HISTORIC DISTRICT COMMISSION

Memorandum

Re: Updated 421 W Washington Street HDC application (HDC26-0028)

3 Second Floor Plan - REVISED 05-29-26
A1.1 SCALE: 1/4" = 1'-0"

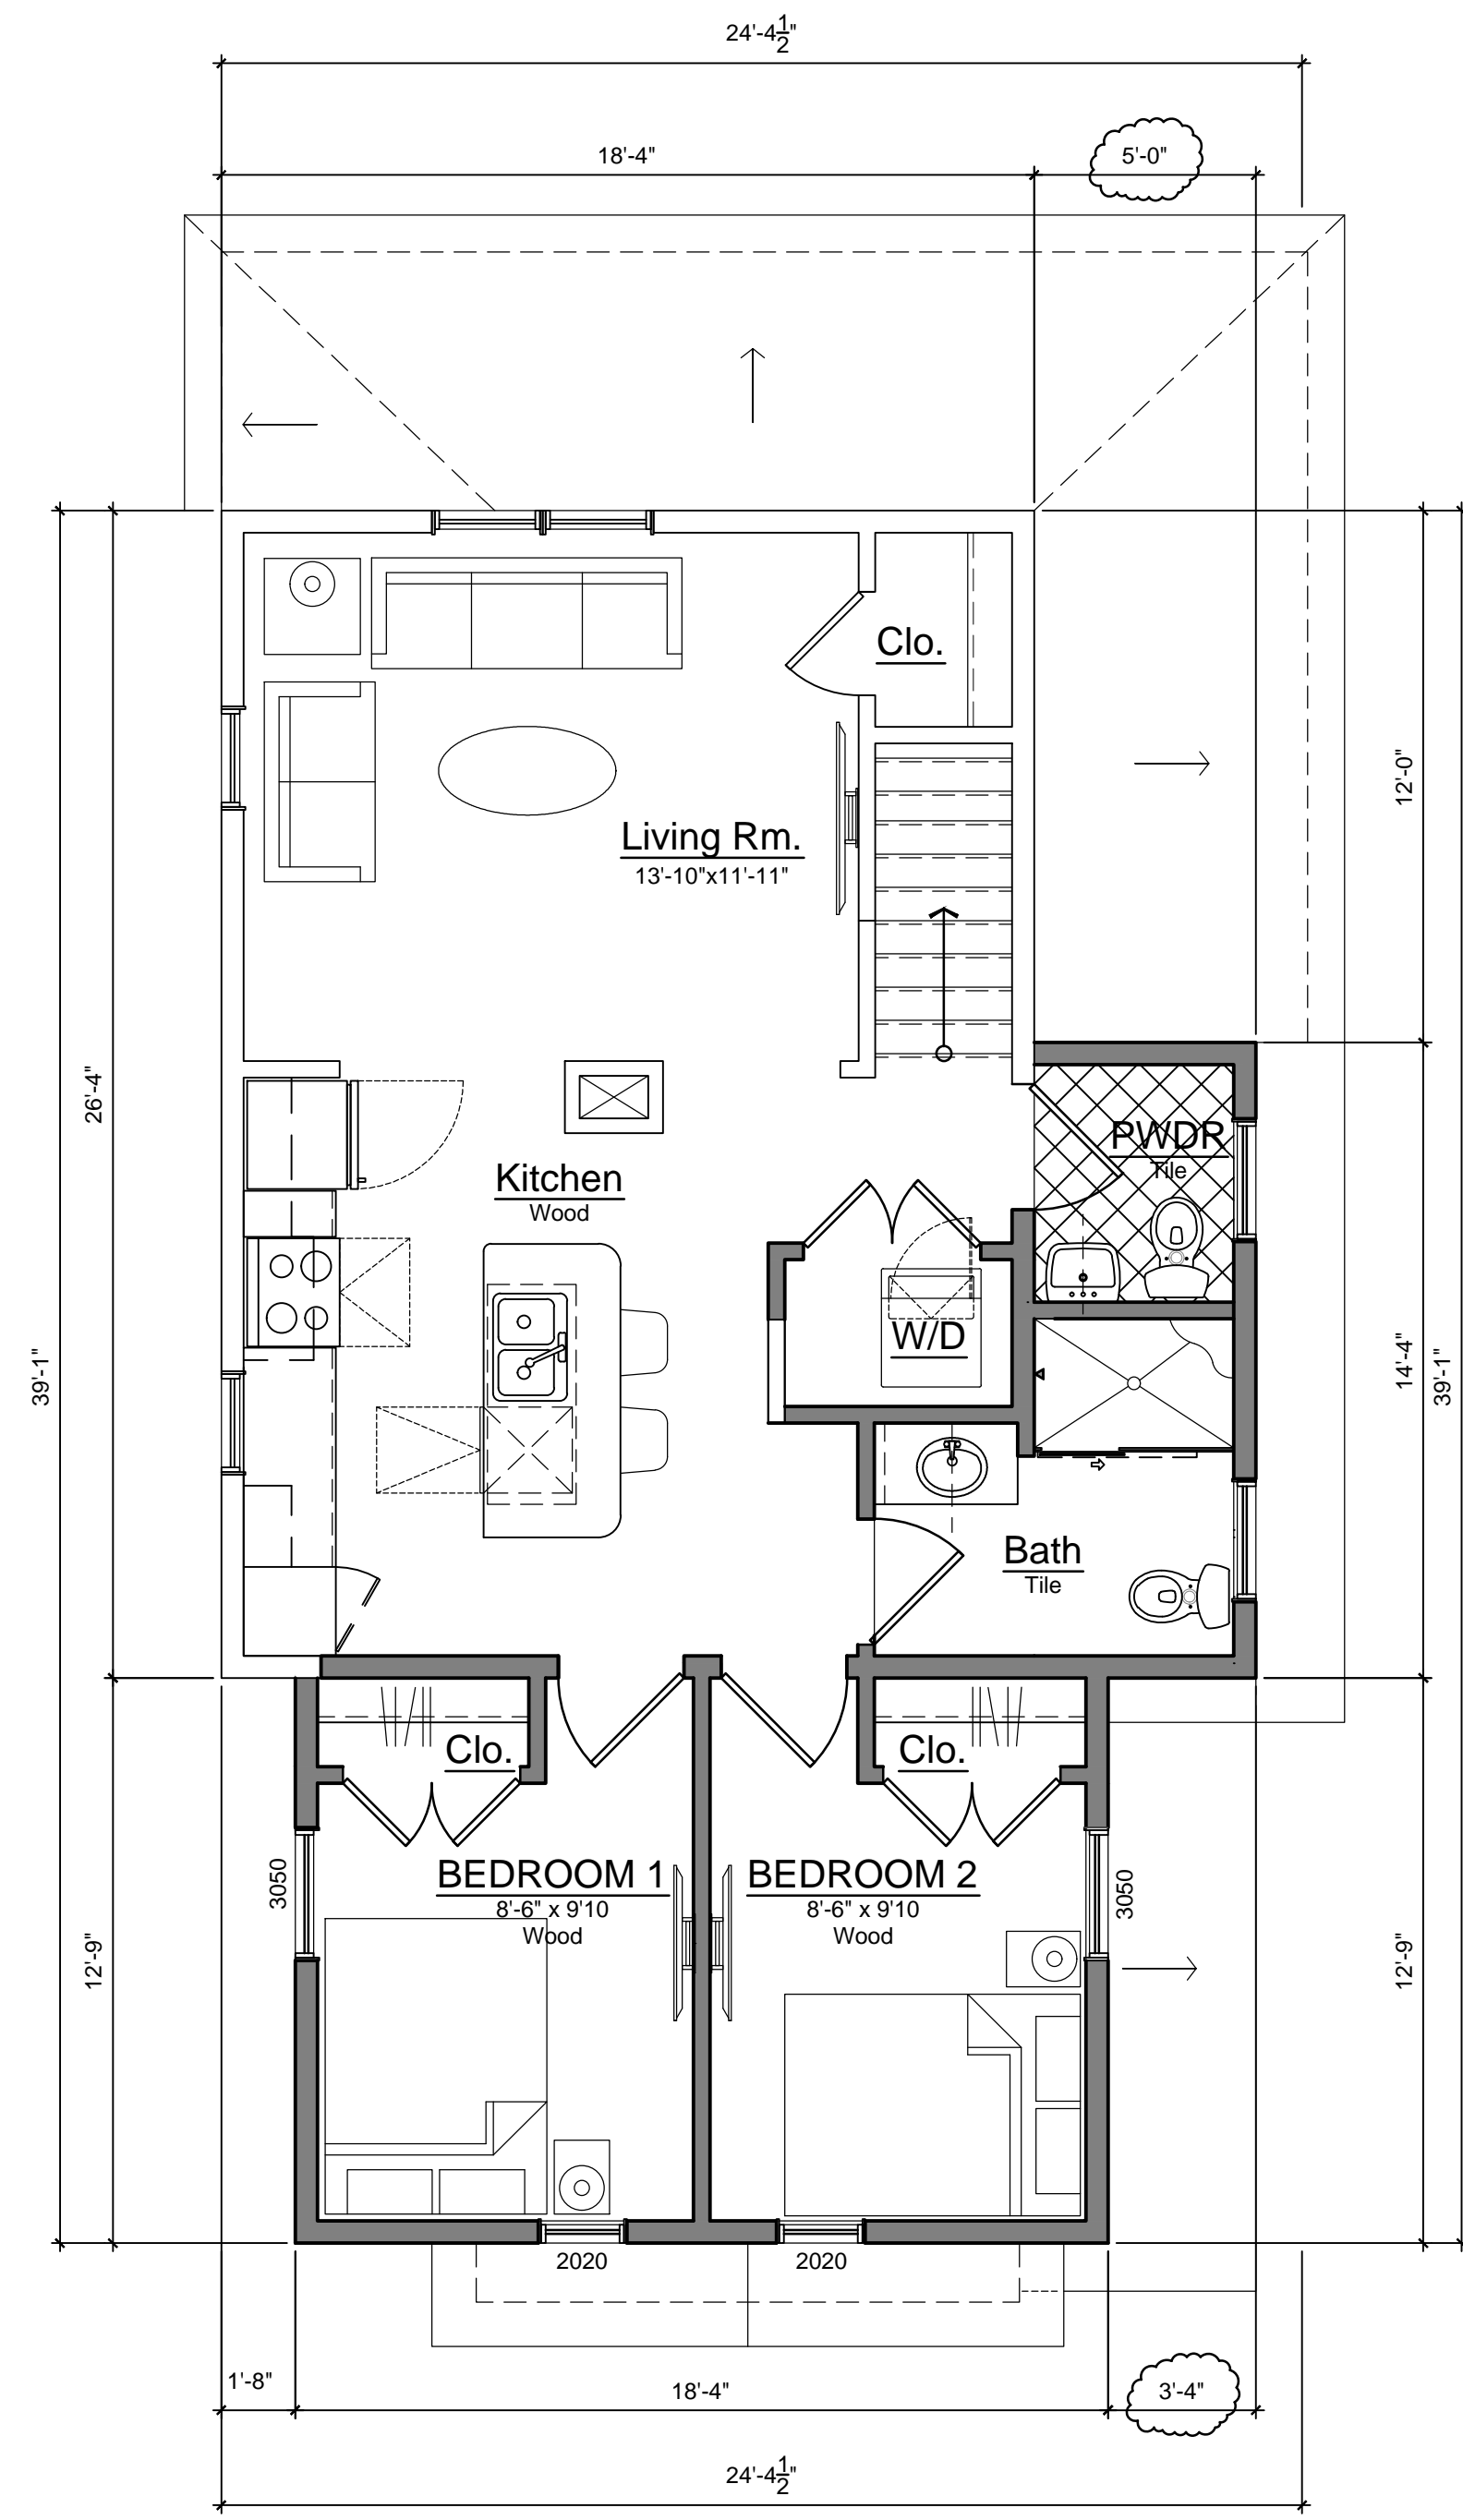
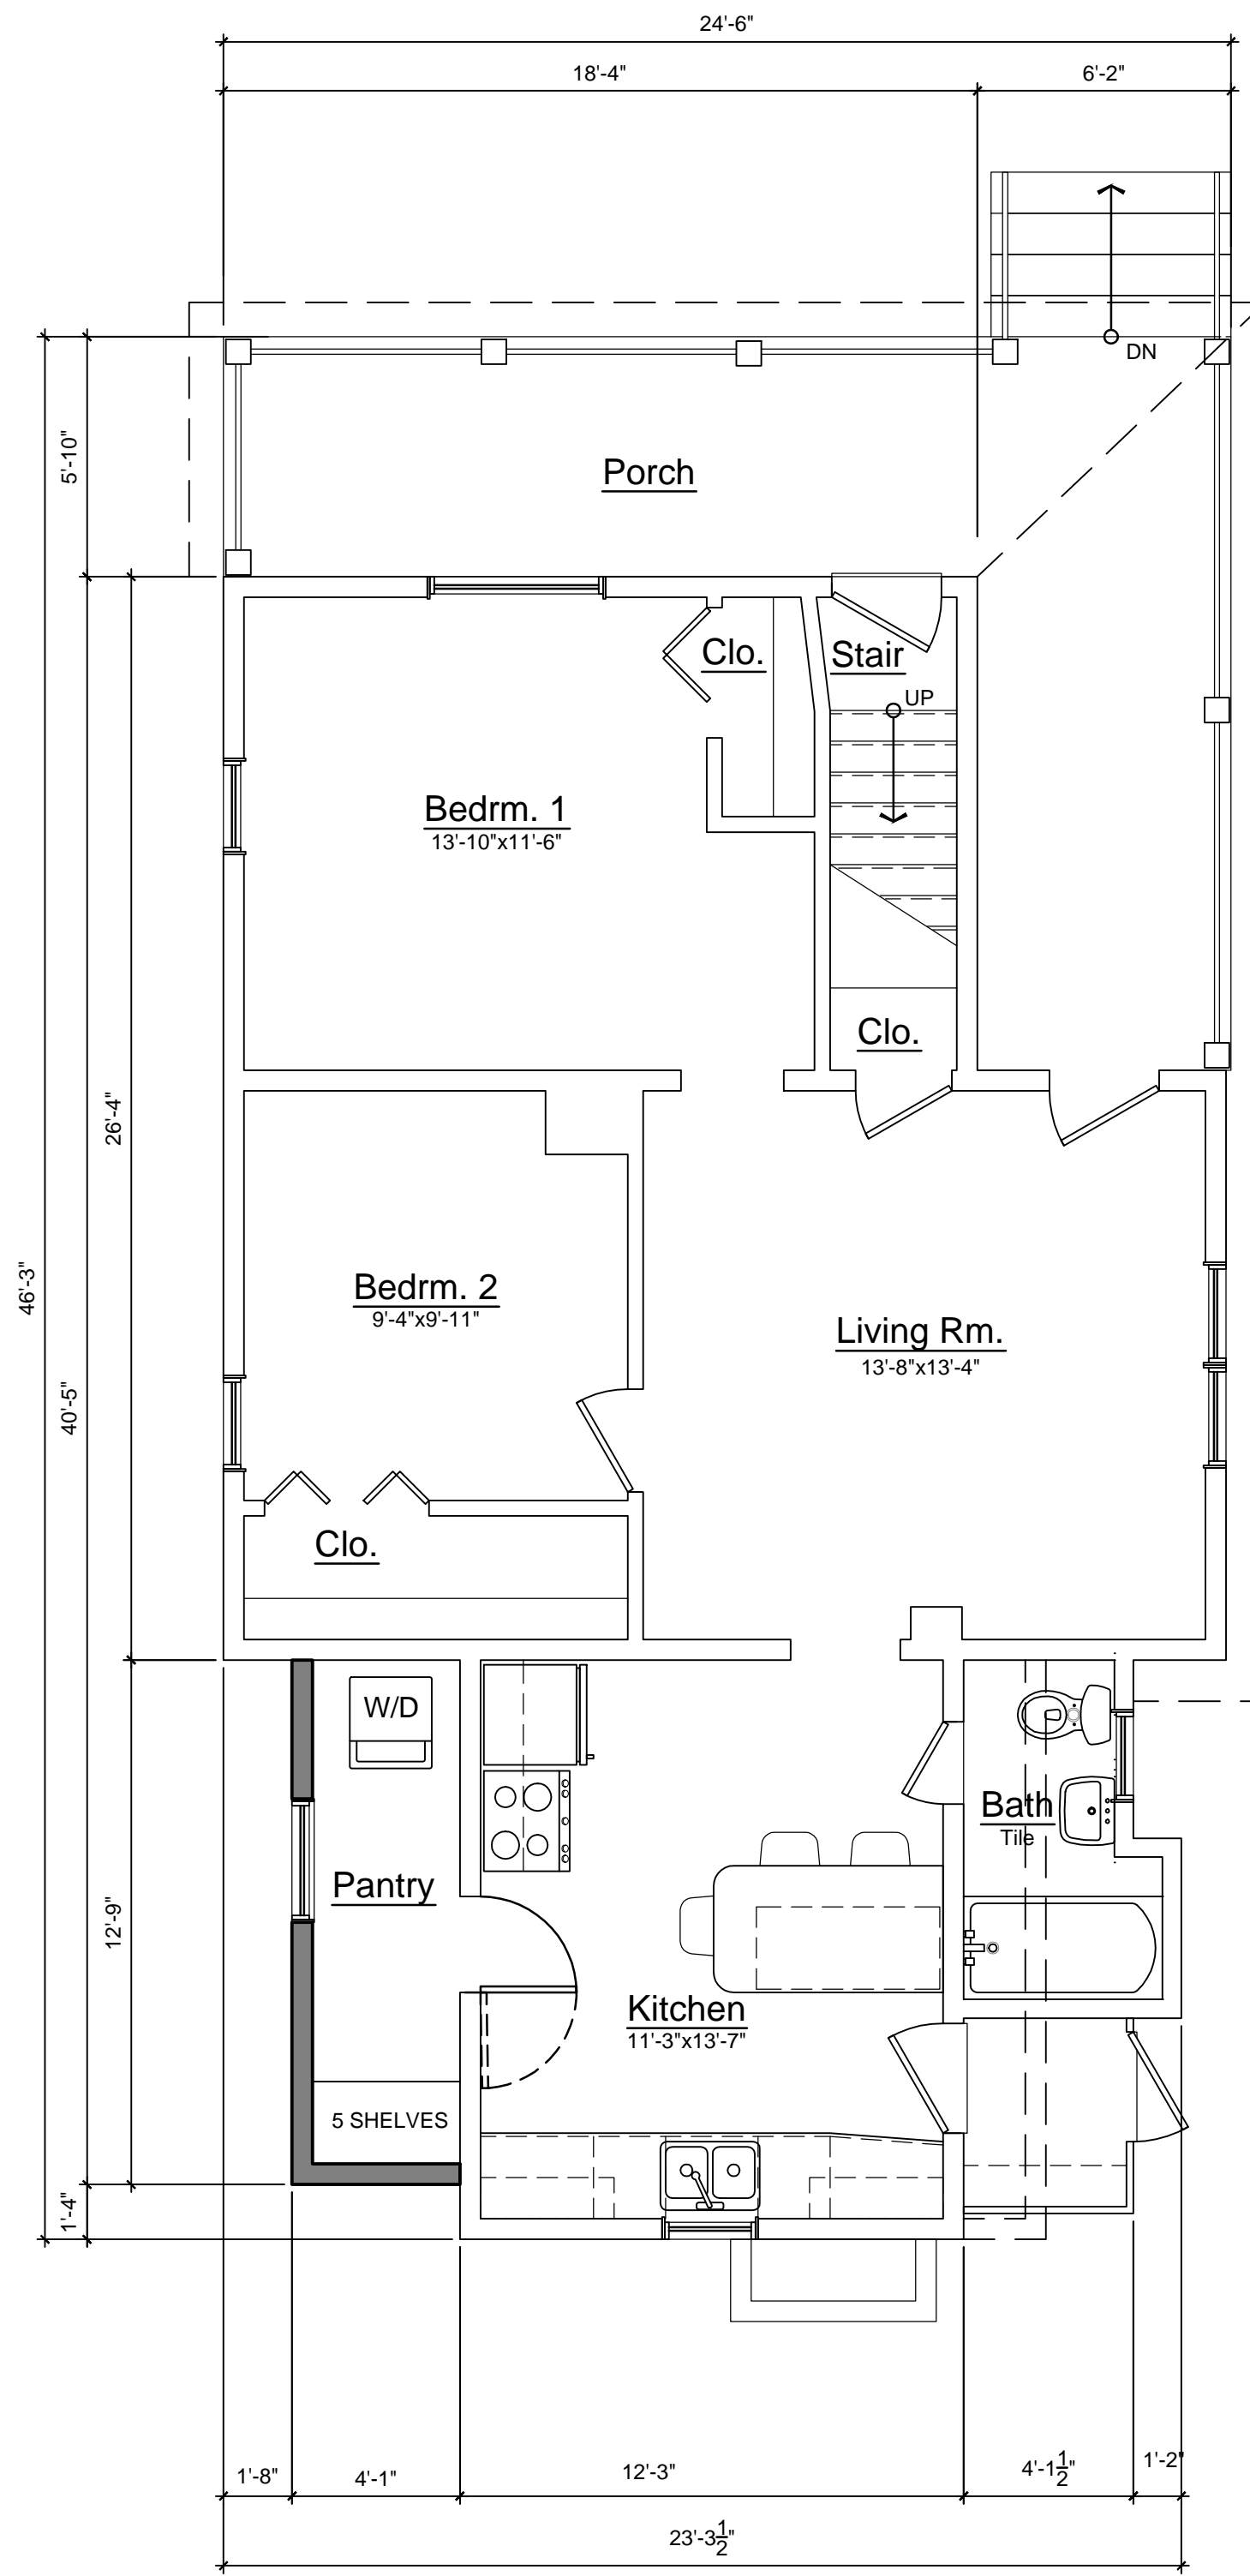
1. The applicant has submitted revised plans showing the east second-story

addition with a shed roof instead of a gable roof to determine if this change would reduce massing and visibility. The addition is also slightly smaller, extending five feet beyond the plane of the east elevation instead of six feet. It will add roughly 72sf off floor area on the second floor instead of 86sf. The rest of the details remain largely the same; the roof will be asphalt shingle and siding will be Hardie plank. Two historic six-over-six windows that would be removed during construction will be reused on the east side of the addition.

4 Proposed South Elevation - REVISED 05-29-26
A2.2 SCALE: 1/4" = 1'-0"

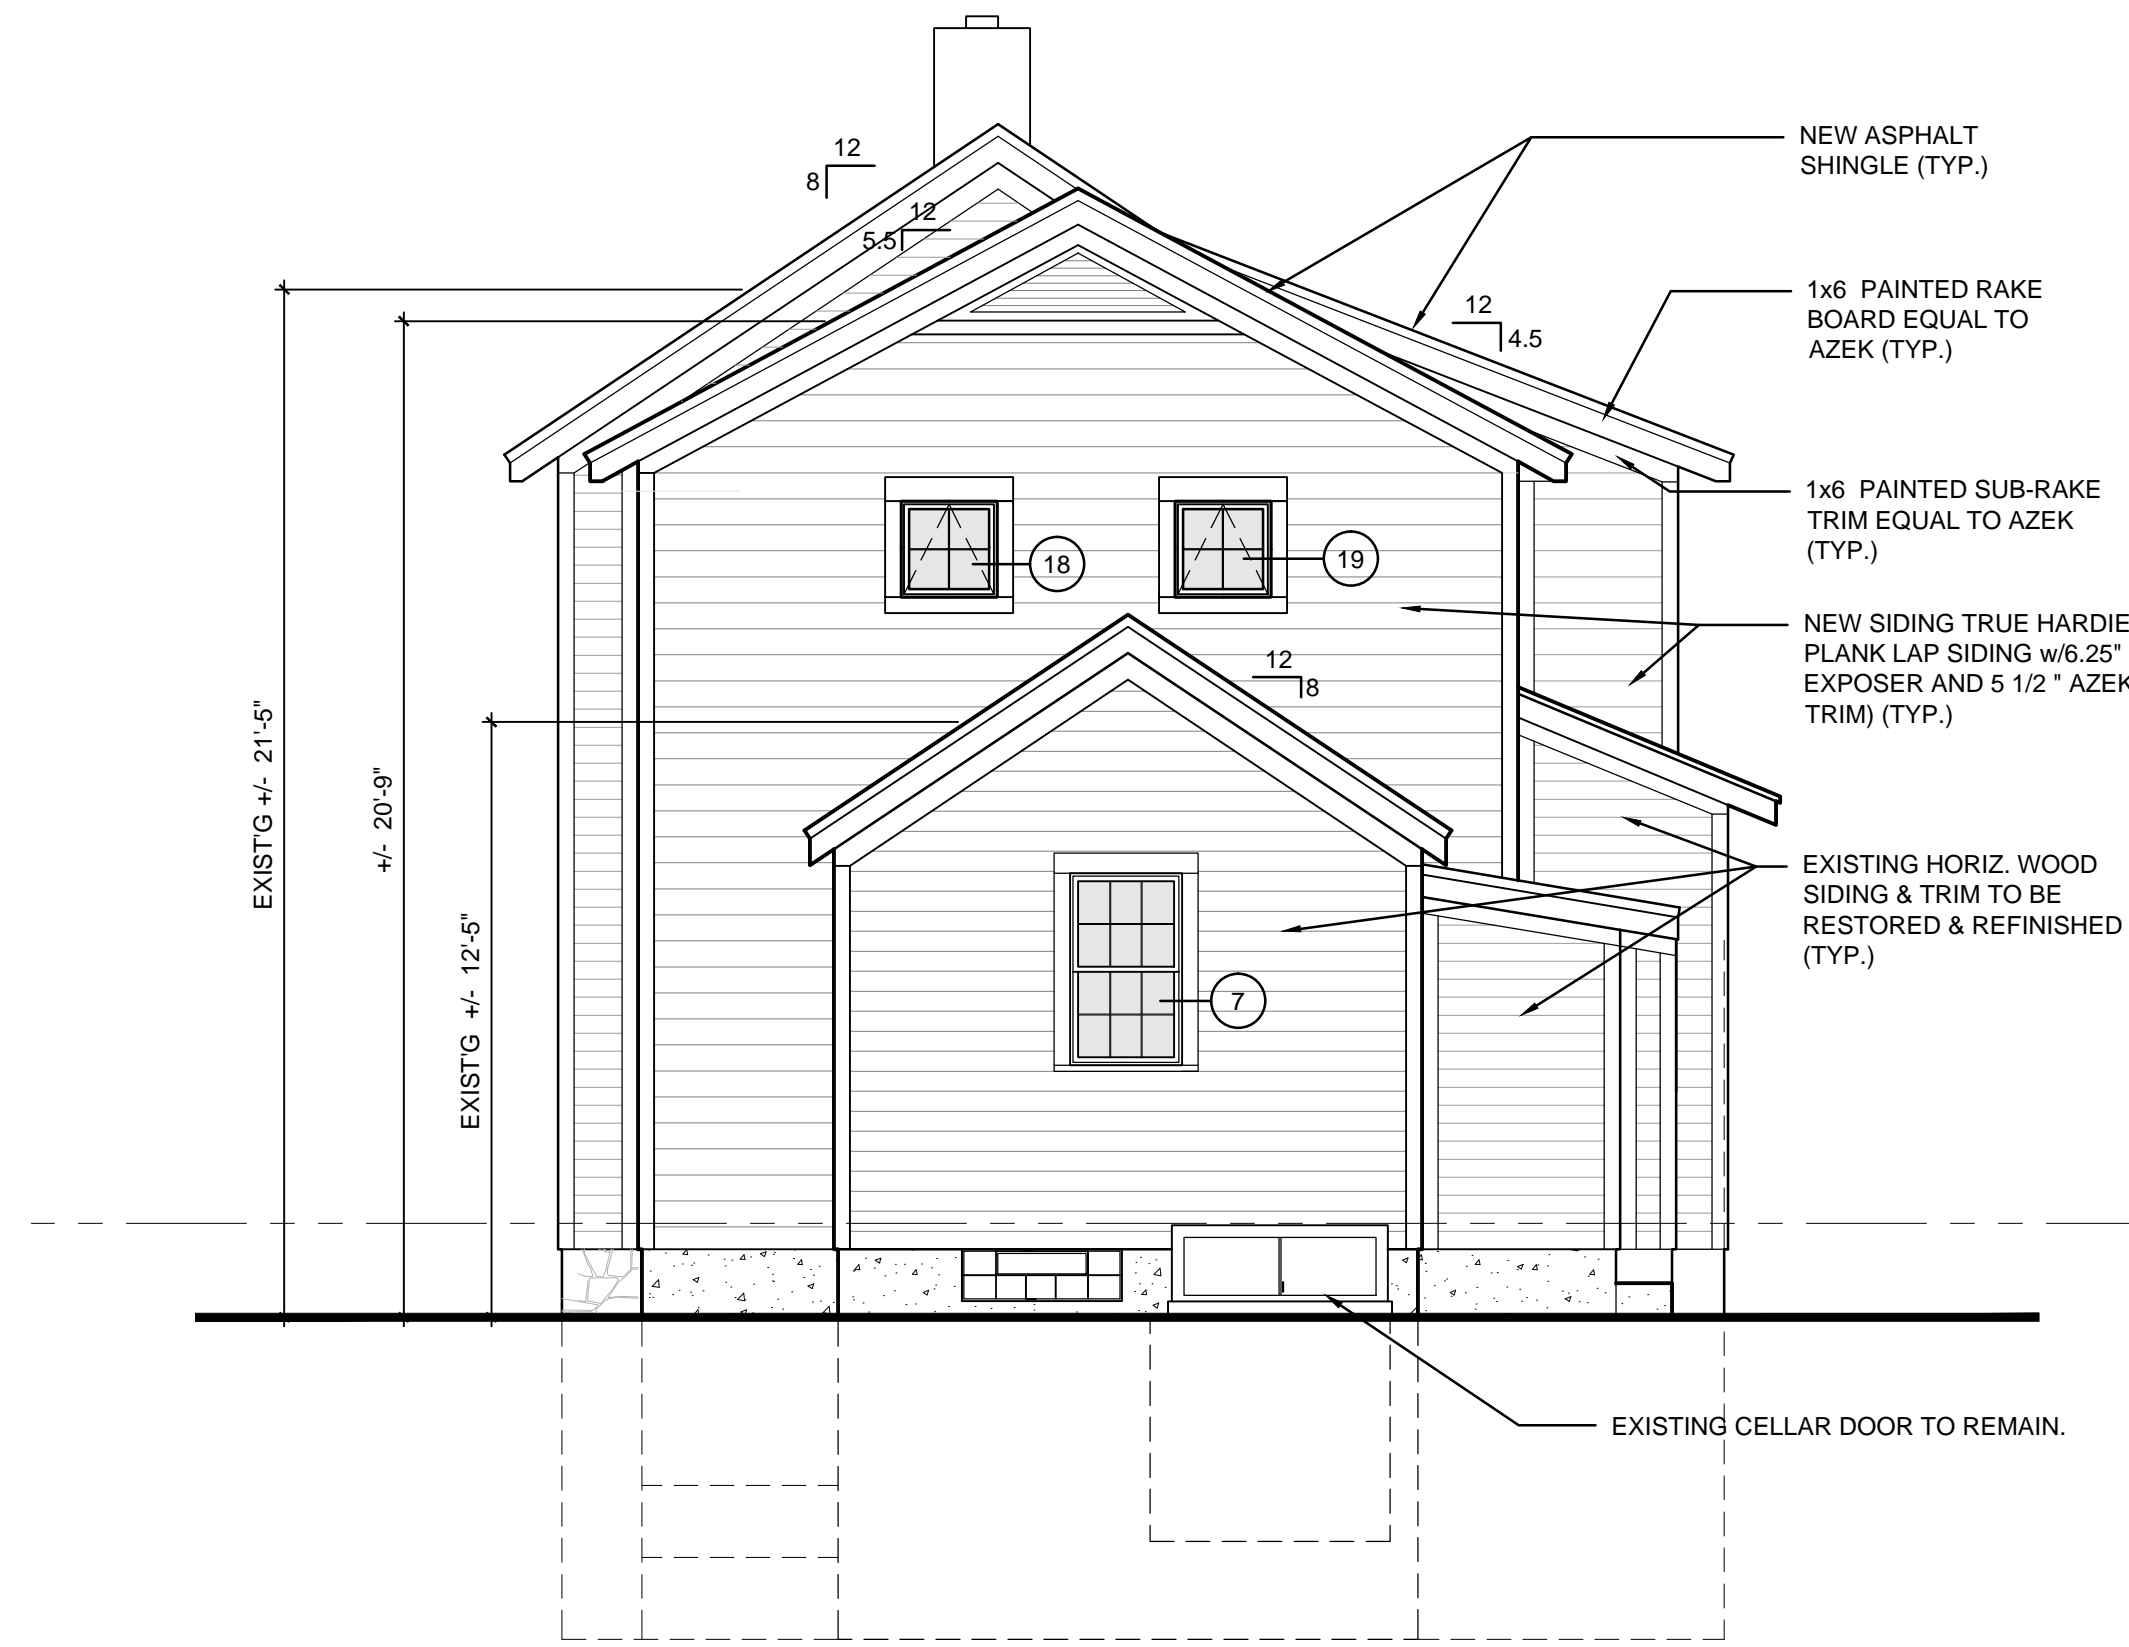
2. The applicant has revised plans to show that the historic siding will be retained and repaired, which will be a great improvement to the house. The siding on the proposed additions will be Hardie plank with a wider exposure to differentiate from the historic siding.
3. The previous drawings for the restored wrap-around front porch showed a concrete base and stairs. In May, the Commission noted that it was very unlikely that the historic porch was concrete and that new concrete would obscure and damage the stone foundation. The applicant now proposes a non-concrete porch base with a PVC lattice skirting. While the design shown in the drawings is much more appropriate, the materials are not specified for the decking and stairs, and PVC is not an acceptable lattice material. A condition is included in the suggested motion that the porch elements will be wood.

The applicant has also updated the proposed posts to be simple 7in wood posts. A simple design is appropriate if the design of the historic porch posts is unknown. There is a note on the drawings that the posts will be turned if ghosting of historic turned posts is found on site during construction. If there is physical evidence of turned posts on site, then restoring the design is appropriate.

Overall, staff finds the design of the proposed rear addition to be appropriate. The addition has a simple design, would be sufficiently differentiated from the historic house, would have limited impact on historic materials, and would be minimally visible from the right of way.
